**Basement Impact
Assessment Audit**

194 Goldhurst Terrace,
London NW6 3HN

For
London Borough of Camden

Project No.
14006-53

Additional information

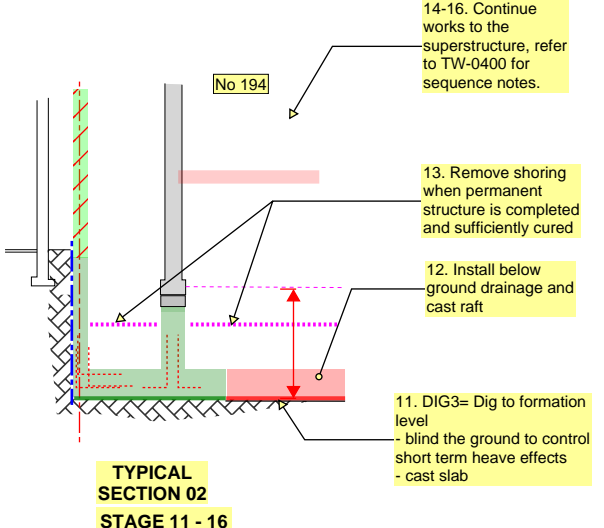
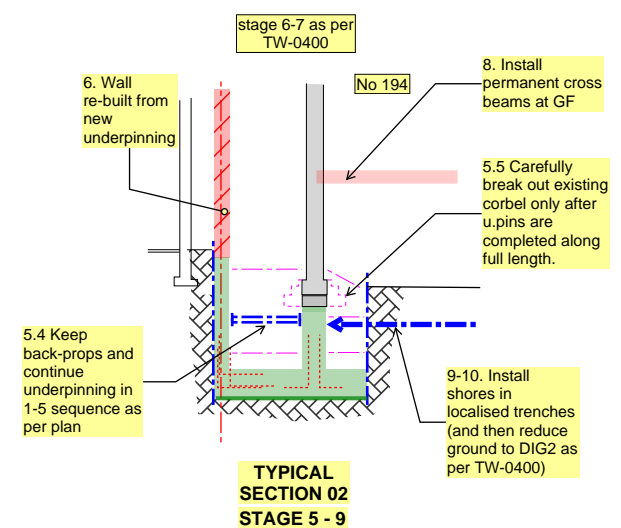
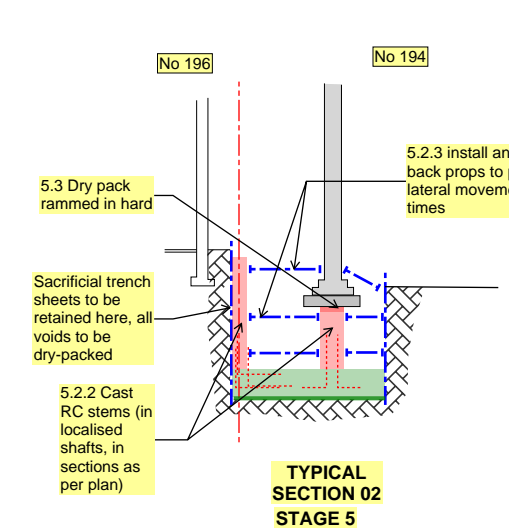
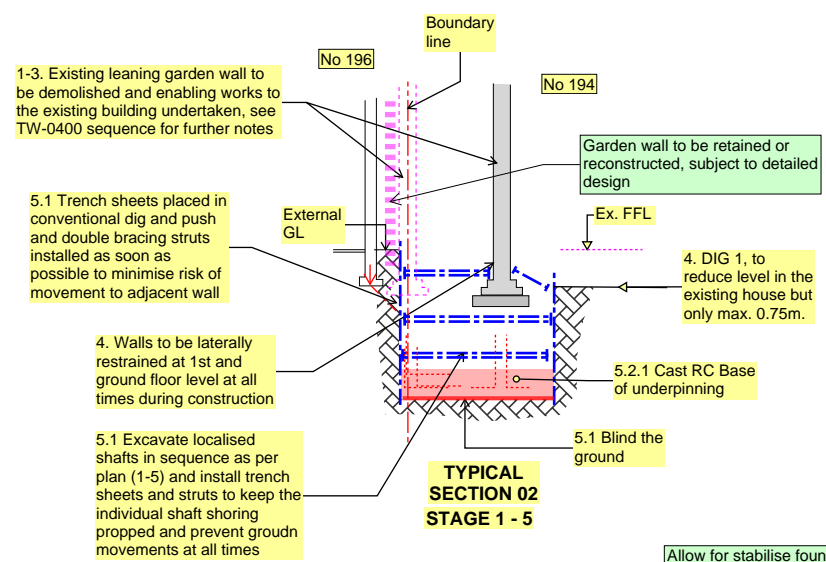
- 4.17 The screening and scoping also suggests that the development is within 5m of a highway or pedestrian right of way and will increase the differential depths of foundations relative to neighbouring properties. The scoping identifies that the neighbouring properties closest to the proposed basements include No. 192 and No. 196 of Goldhurst Terrace and thus a Ground Movement Assessment has been carried out. The additional documents provided confirm that the highway is some 4m from the nearest point of the proposed basement (included in Appendix 3).

Date: 12/2023	Scale at A1: 1:50	Scale at A3:
Drawn by: SW	Designed by: AP	Chk'd by: AP
Drawing No: 23091-ASL-SK-TW-0401	Revision:	P2

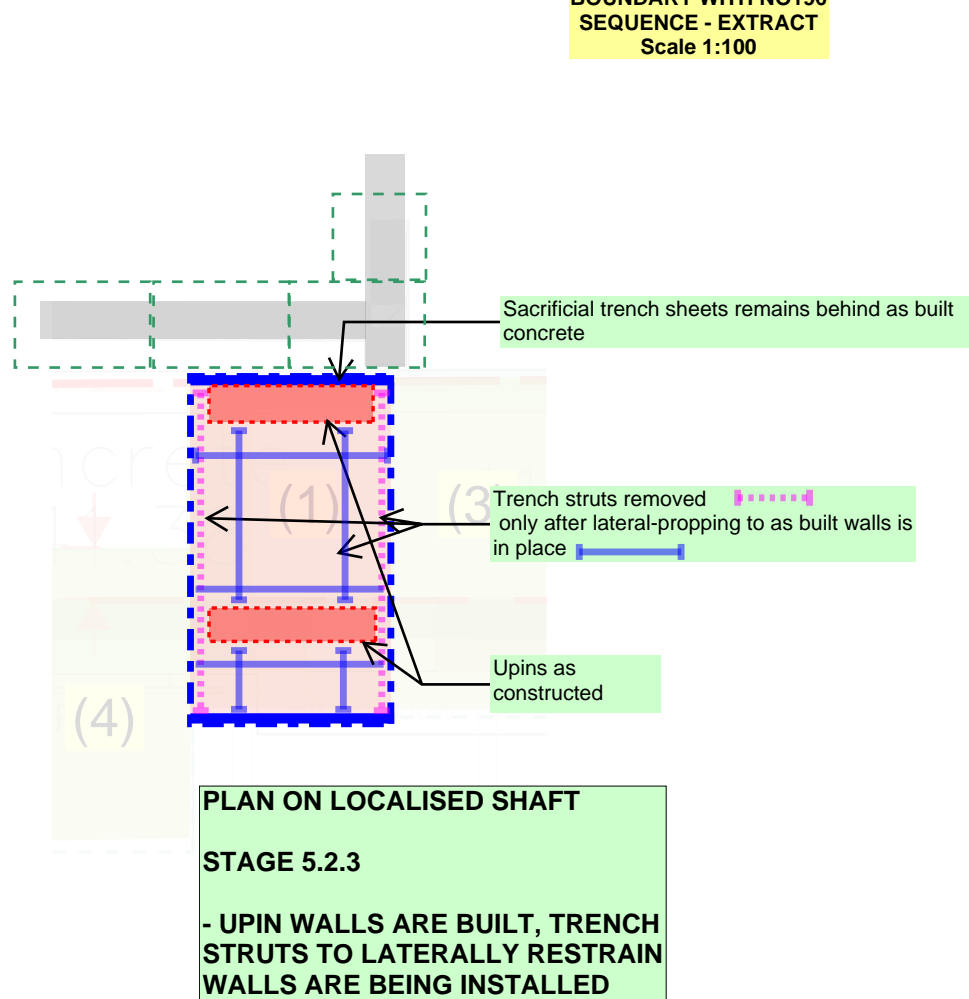
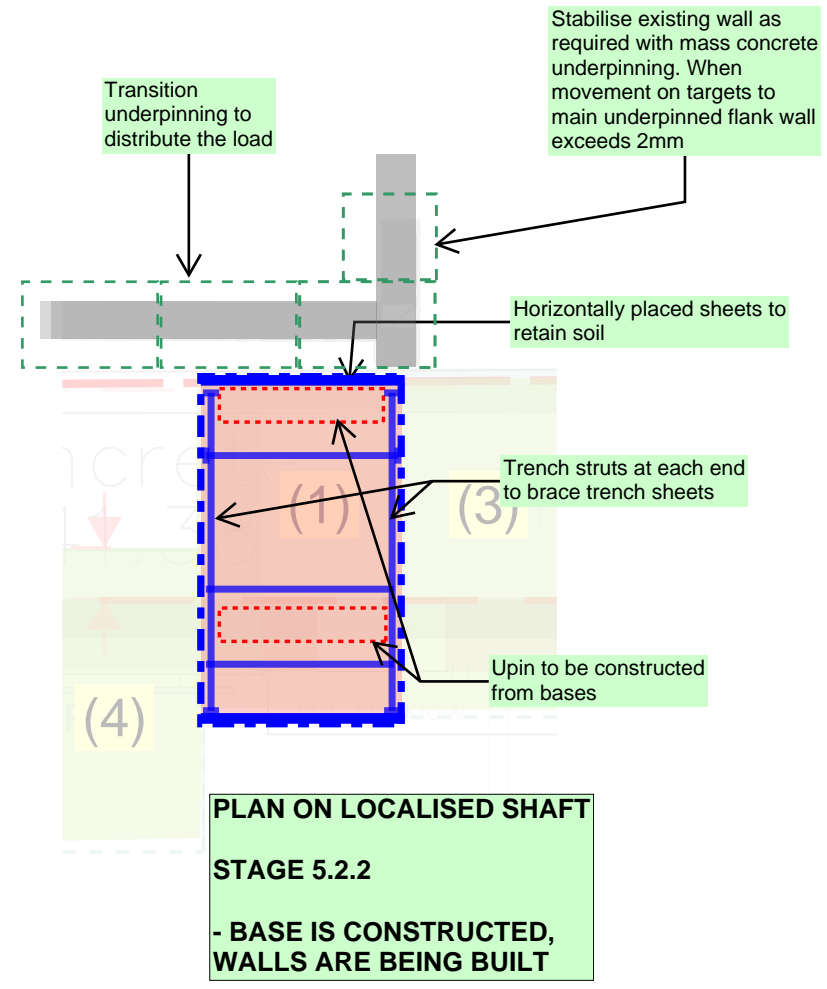
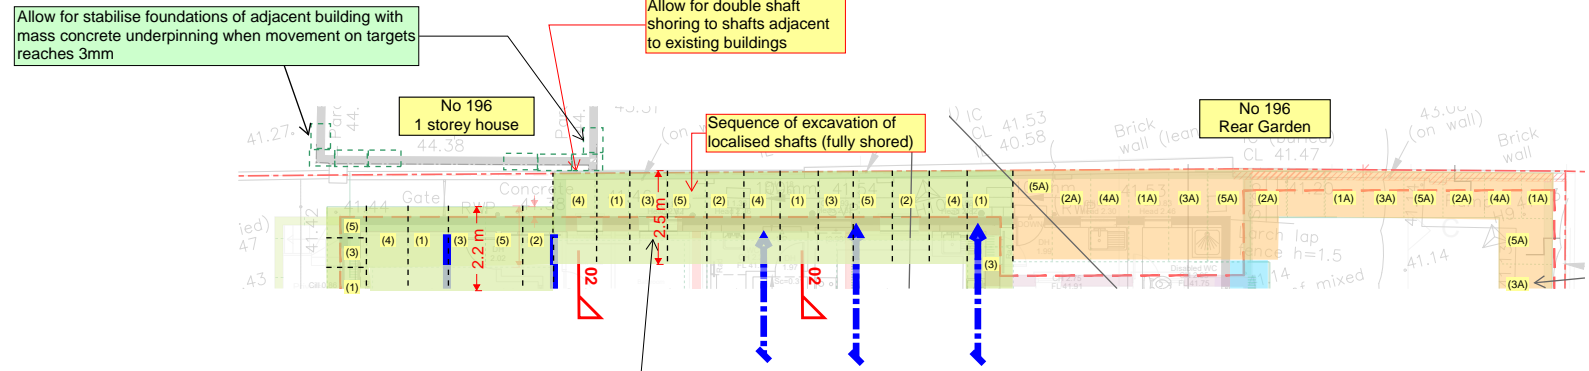
- 4.20 Drawing 23091-ASL-SK-TW-0401 P3 shows the existing garden wall will be demolished and sections approximately 1m wide will be excavated beneath the external walls of the main

property. Sacrificial trench sheeting will be installed along the site boundary using a conventional dig and push method supported with double bracing struts to maintain stability and the reinforced base slab will be cast across the ground. A reinforced concrete wall will then be cast against the trench sheeting and the external wall will be underpinned. The drawing provides additional information regarding the methodology and confirms the props will remain in place during the curing of the retaining wall and underpin section (included in Appendix 3).
